City of Baker School Board
Board Meeting Agenda
Tuesday, June 4, 2024, 6:00 P.M.
School Board Office

**City of Baker School Board Meeting
May 7, 2024**

To: Manning Architects **DATE:** 4/25/2024
FROM: Jason Catlin **QUOTE #:** 077
PROJECT: Baker High School Renovations and Additions
DESCRIPTION OF CHANGES: RFI 160 & 191 Cost for Mods of Ductwork to Fit in Ceiling Space & Added Smoke Damper

CHANGE ORDER INFORMATION:
Change Order Number: 008
Date: 5/30/2024

SHEET NO. **M-1.B1**

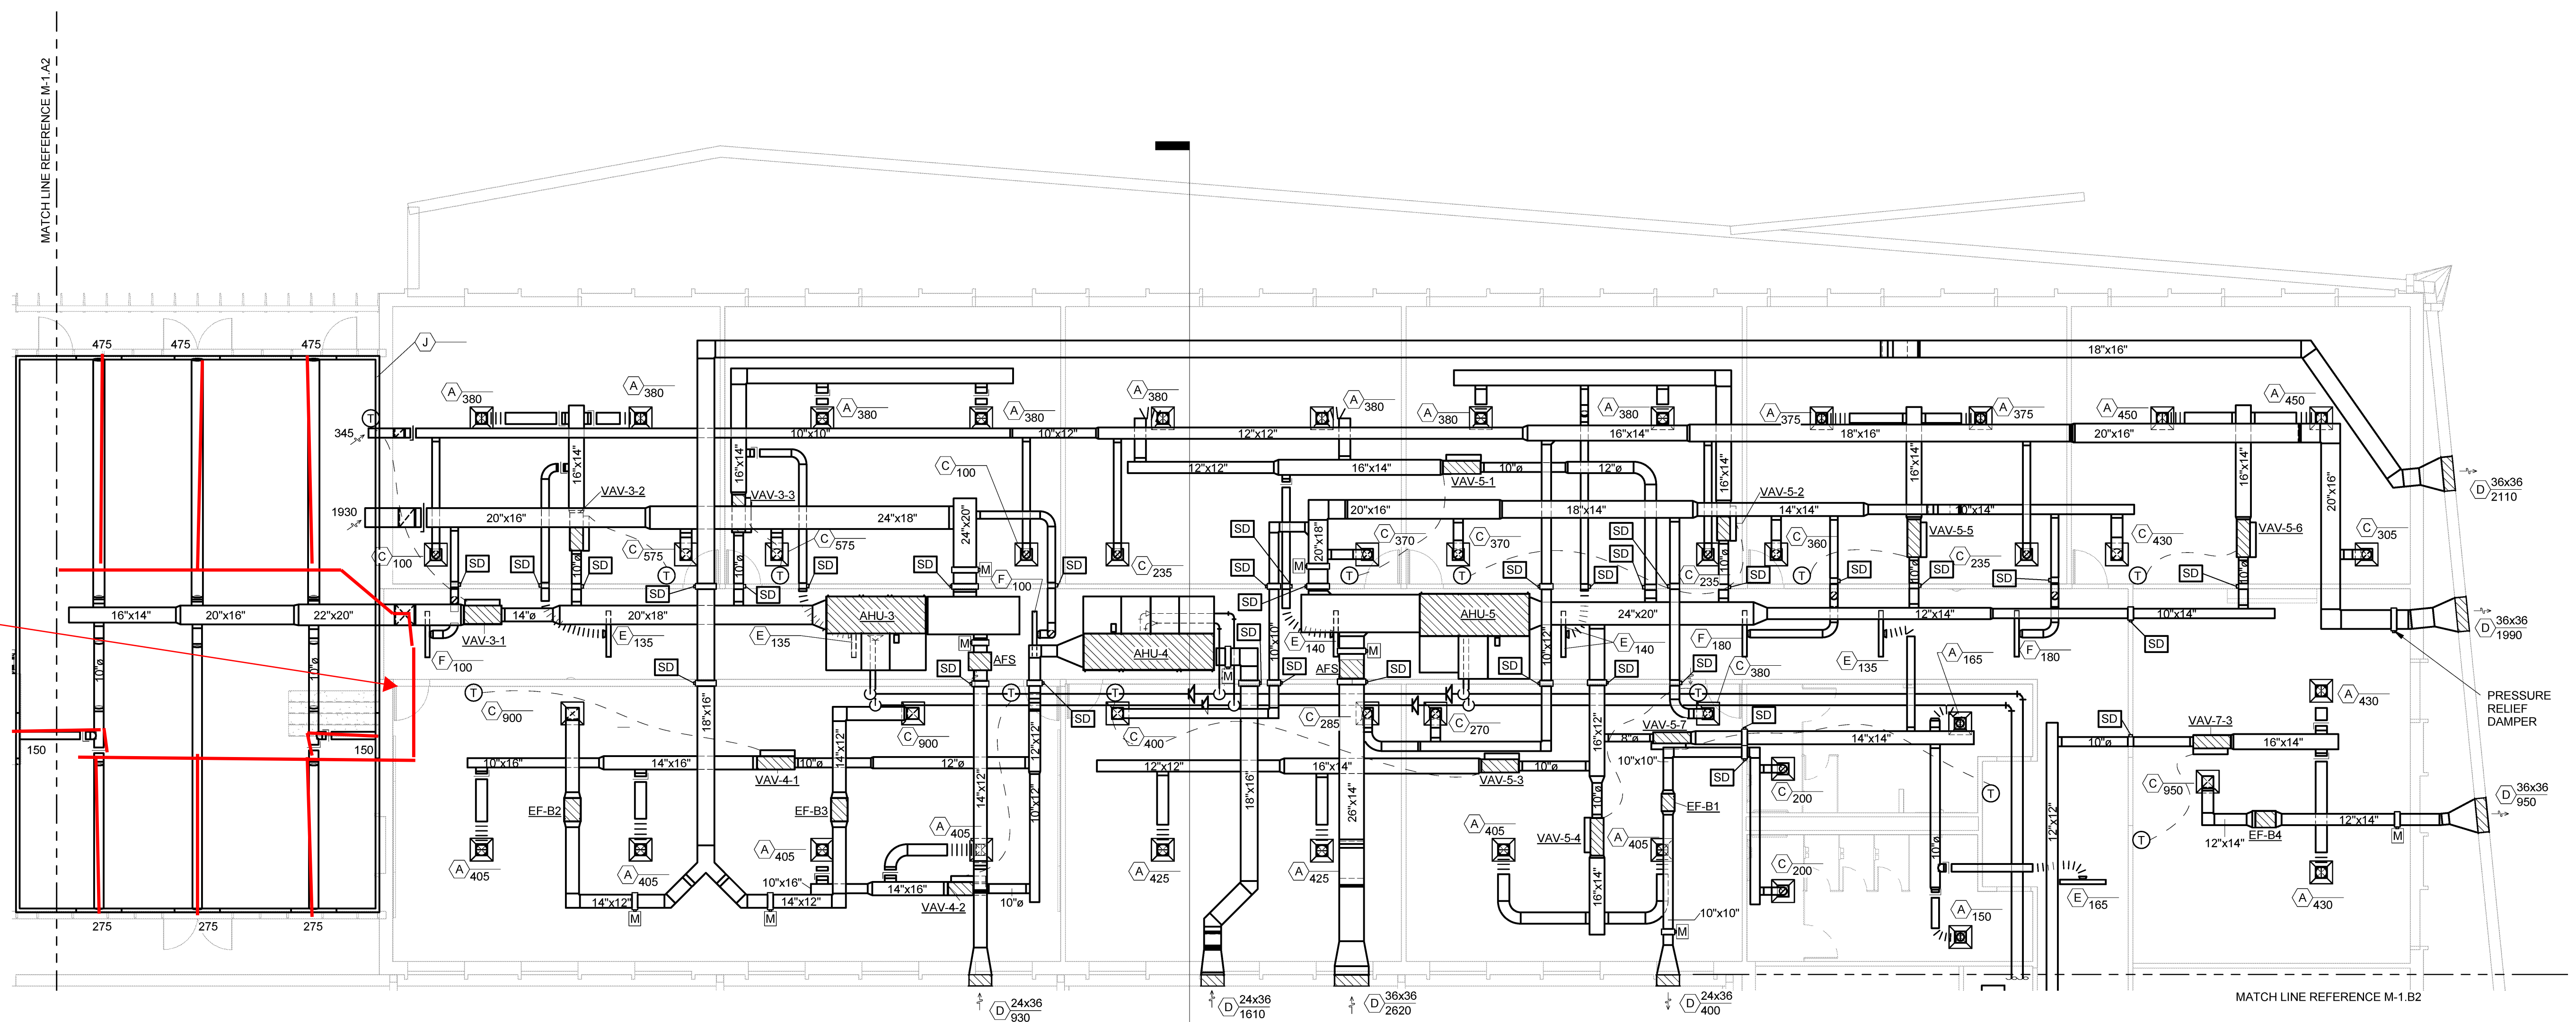
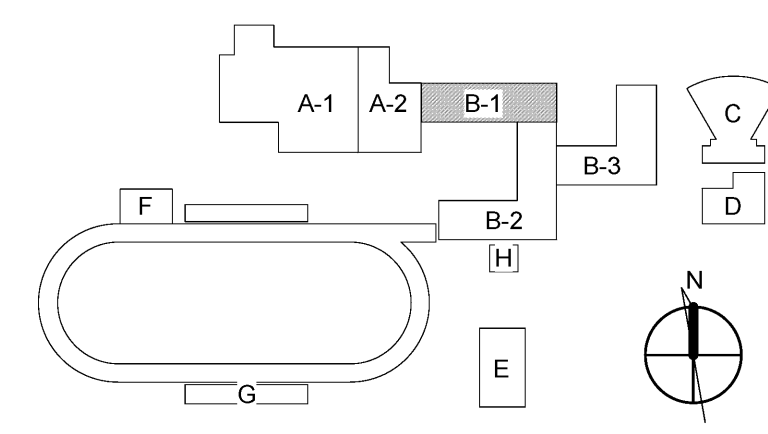
The trunk line in connection is 22x20 decreases to 20x20 then to 16x20 which will still have insulation wrapped around them. These will not fit in the ceiling space and the ceiling grid cannot just be lowered. Please provide revised dimensions for the duct work to allow it to fit in the 16" space.

RFI 160 approved splitting the trunk line in Entry Lobby so it could fit in ceiling space. See attached routing and advise if smoke damper is required at hallway penetration.

I think I can make this work. would I need to add a smoke damper where the 14x16 goes through this wall in the hallway.

Split the ductwork before it enters the lobby space and provide two main duct branches in lieu of just one shown on the drawing. One main branch will provide airflow to the three diffusers on the north side of the room; that main duct run should be 14"x18" size. After the first run-off the ductwork can reduce to a 14"x14" size. The second main branch will provide the airflow to the five remaining diffusers near the southside of the room; that main duct run should be 14"x16" size.
